Weldale Street

Daylight and Sunlight Assessment –
Updated for Section 73
Resubmission

Report for Ropemaker Properties

APPENDIX E – HYDROCK RESPONSES TO BRE
AND PLANNING OFFICER COMMENTS UNDER
APPLICATION 170326

Figure 11 - The Chatham, without access decks

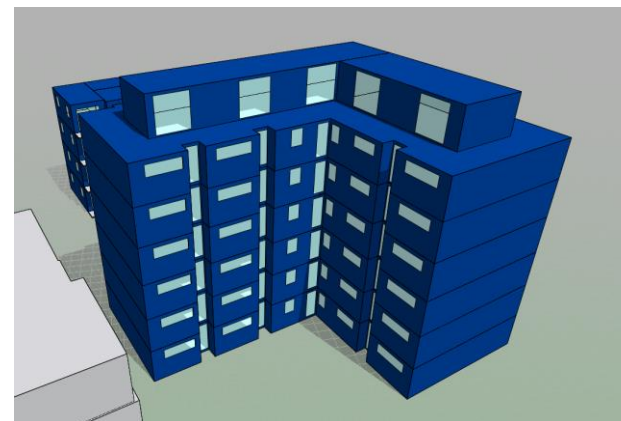
4.4.5	<i>There are large relative losses in light, although these are partly due to the access decks above the windows which restrict access to light from overhead. In this type of situation, the BRE Report suggests carrying out an extra analysis without the overhangs in place. This has not been done, though it is likely that it would show lower relative losses of light. Overall the loss of daylight would be classed as moderate adverse impact for this reason.</i>	While the BRE guide suggests to carry out an additional test without the access decks, modelling the daylight without the access deck will provide results which are not true to reality and will down play any adverse impact on the Chatham apartments. Hydrock have performed this additional check within the report.

The Chatham was remodeled without the access decks as shown in Figure 11.

With the access decks removed the majority of windows are meeting the guidelines set by the BRE. In this case, 8 no. windows are experiencing a reduction in VSC greater than 20% and are therefore failing to meet the guidance, all other windows are passing.

Figure 24 - Amenity sunlight hours (coloured areas represent spaces where 2 hours of sunlight is achieved)

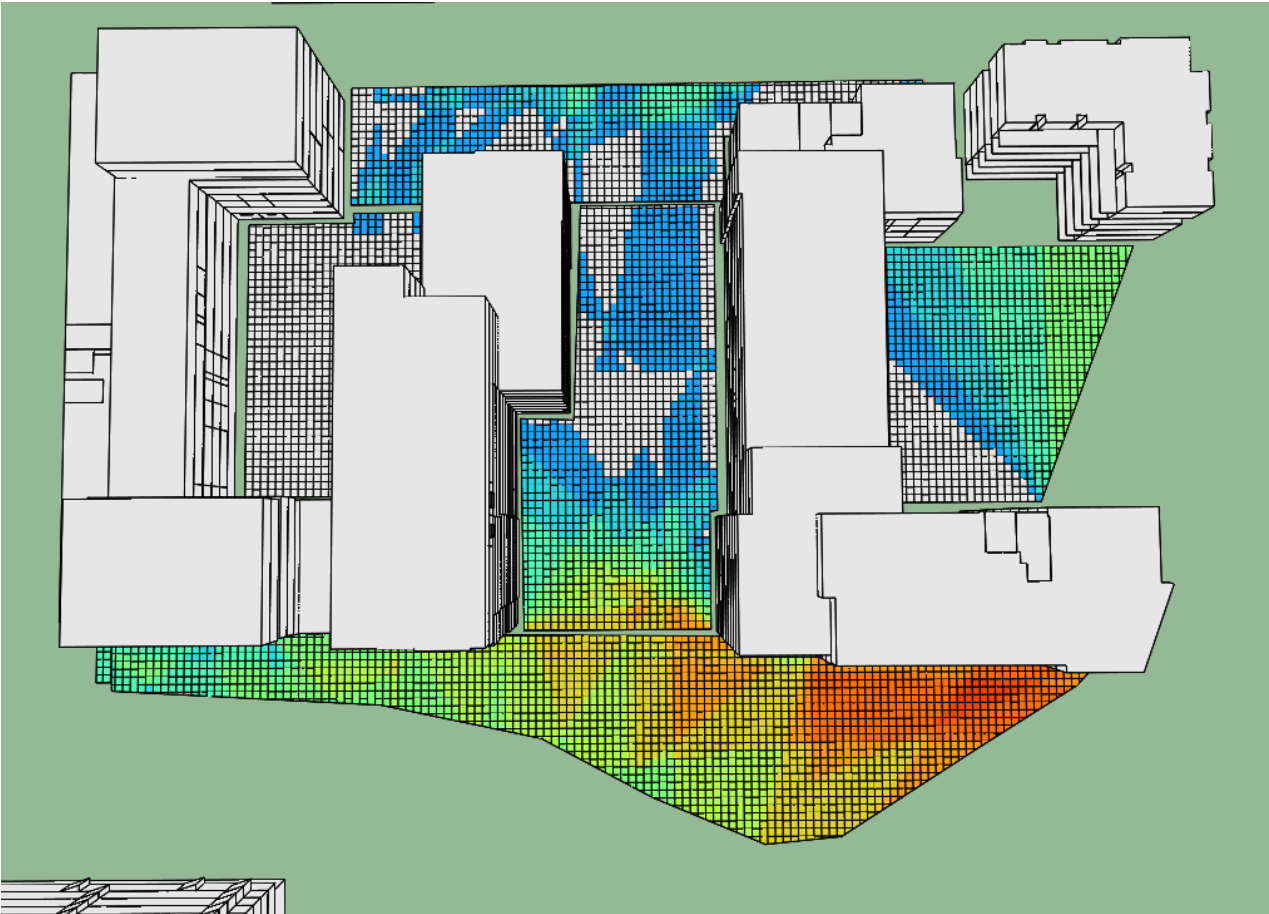
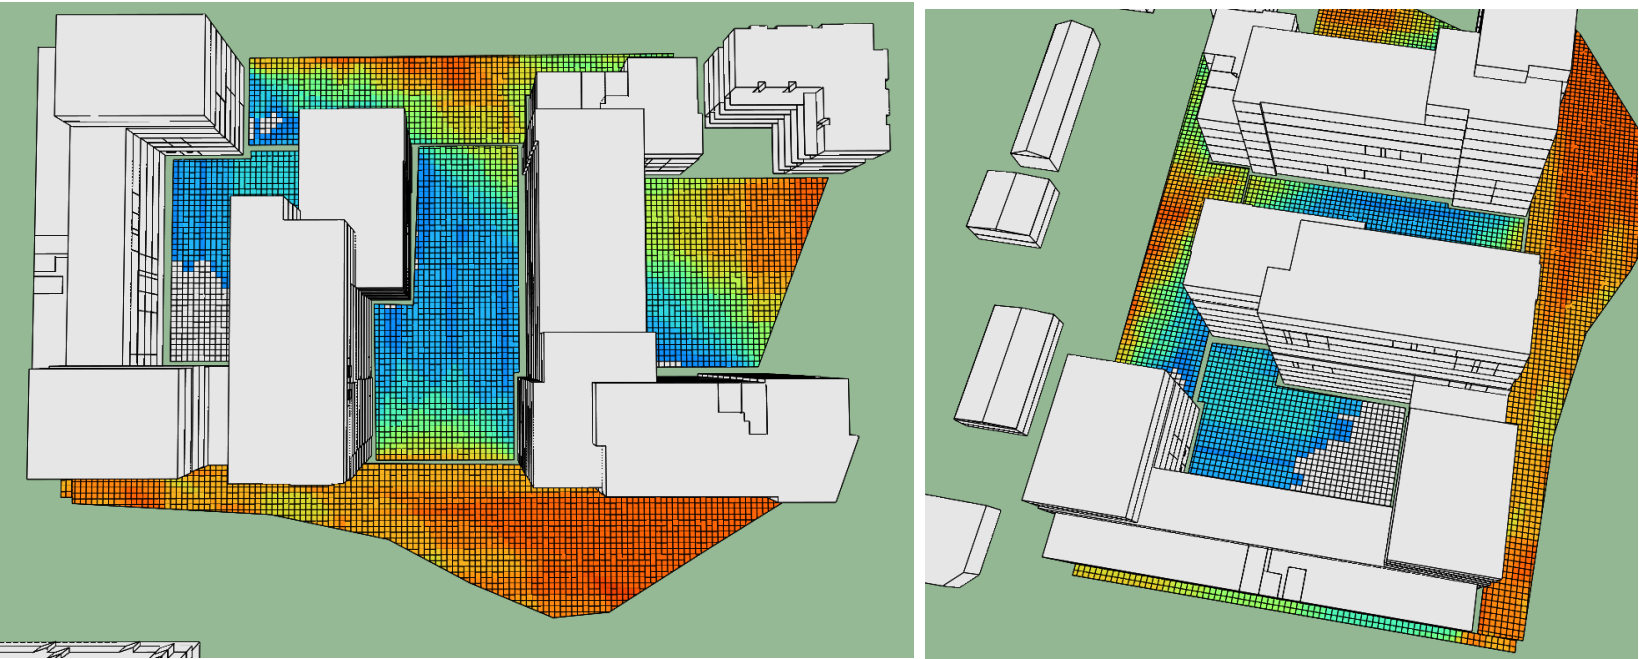
6.4	<i>The courtyard to Block A would not meet the BRE guidelines with virtually none of it receiving two hours of sunlight on March 21st. This space would be poorly sunlight.</i>	This is correct, during the period of September - March this courtyard will not receive a great deal of sunlight. However during these periods residents will have access to a number of other communal areas within the site that do receive good levels of daylight if they wish to use them. During the summer, the sunlight performance of this courtyard increases greatly with half of the space receiving more than 2 hours of sunlight. This is more fitting to the time of the year that residents will wish to use the space for amenity, rather than a access/egress route to get to their apartment. The architect has produced a study showing how changes to the massing will change the sunlight performance of this building. This is included within the appendices of the Daylight and Sunlight report.

Figure 30 - The Chatham window labeling

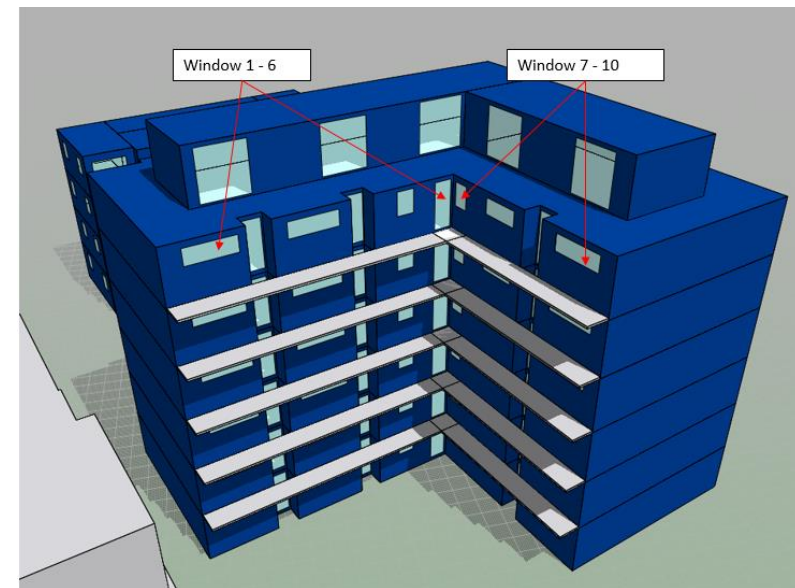
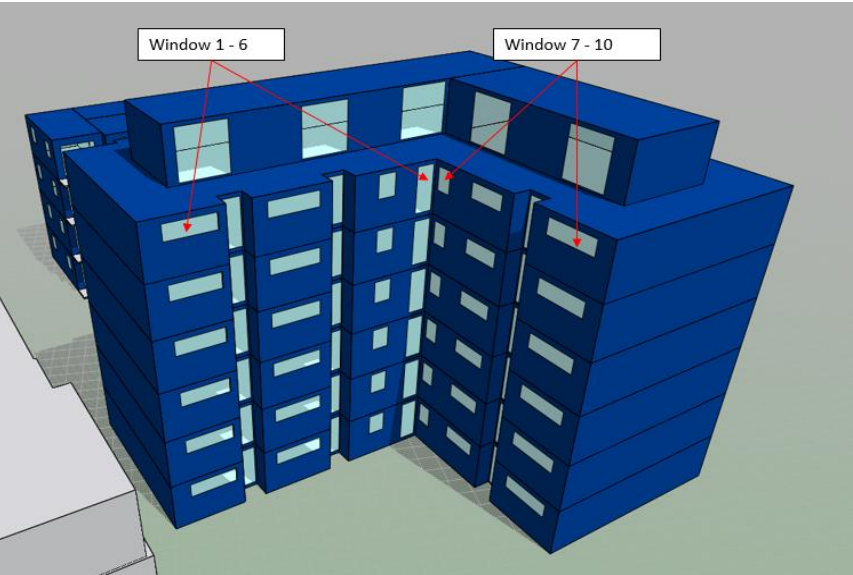
Comment	Planning Officer Comment	Hydrock Response
Section 4.4	<i>Daylight impact on The Chatham – the review has highlighted inaccuracies in the modelling of the building, suggests that an additional test (without the overhangs – paragraph 4.4.5) should be carried out and that the sunlight results have been presented incorrectly. It is considered, owing to the current findings and the fact that objections to the scheme have been received to the application on this basis, that all matters raised by BRE need to be addressed and re-presented by you, so that the impact on this building can be shown to have been fully assessed and considered.</i>	Amended as per BRE comments.
Section 5	<i>daylight and sunlight to the proposed residential units – the BRE review has highlighted shortcomings in the methodology used in your assessment. Officers consider that all windows/rooms associated with each façade of each building should be tested from the lowest level up until each window on a façade of a floor of the building comfortably passes the test(s). Please note that this is over and above that referenced by BRE at paragraph 5.1.5 of just the lowest inward floors. Instead officers consider that the assessment needs to be fully comprehensive, to fully and accurately demonstrate the proposed day/sunlight levels for future occupiers and in-turn inform the assessment of the overall quality of accommodation proposed by the scheme.</i> <i>The requirement for at least some of this additional information should not come as a complete surprise to you, based on my emails of 6th March and 21st July. Put simply, it is considered that the methodology you have chosen to follow for the proposed units is highly selective and is considered to undermine the validity of the conclusions reached to date. Instead, it is required for you to provide comprehensive results, which will then enable more accurate analysis / conclusions to be reached. Without the additional results being provided, it will be considered by officers that you have failed to demonstrate the levels of day/sunlight received by future occupiers of the proposed development, which in-turn significantly calls into question the overall quality of accommodation being provided.</i> <i>It is likely that BRE will be sought to review the addendum report you are requested to submit, to verify the updated results/findings made. I would welcome your initial agreement to fund the additional review BRE undertakes in the future? Furthermore, please also provide timescales by which an addendum report will be submitted by you, so that I can advise BRE that this will be forthcoming (if you outline the precise scope of the addendum report, this will enable me to seek a quotation from BRE in advance of your addendum report being submitted</i>	Hydrock recognise the Council's wish to have a more comprehensive analysis and propose to carry out additional modelling to satisfy this. The council agreed that the following scope was acceptable: - All units at lower-ground, ground and first floor to be tested - Any failing rooms to be tested on the next floor up - Process to be repeated until a pass is achieved.

The Chatham, Weldale Street VSC Results – Without Overhang
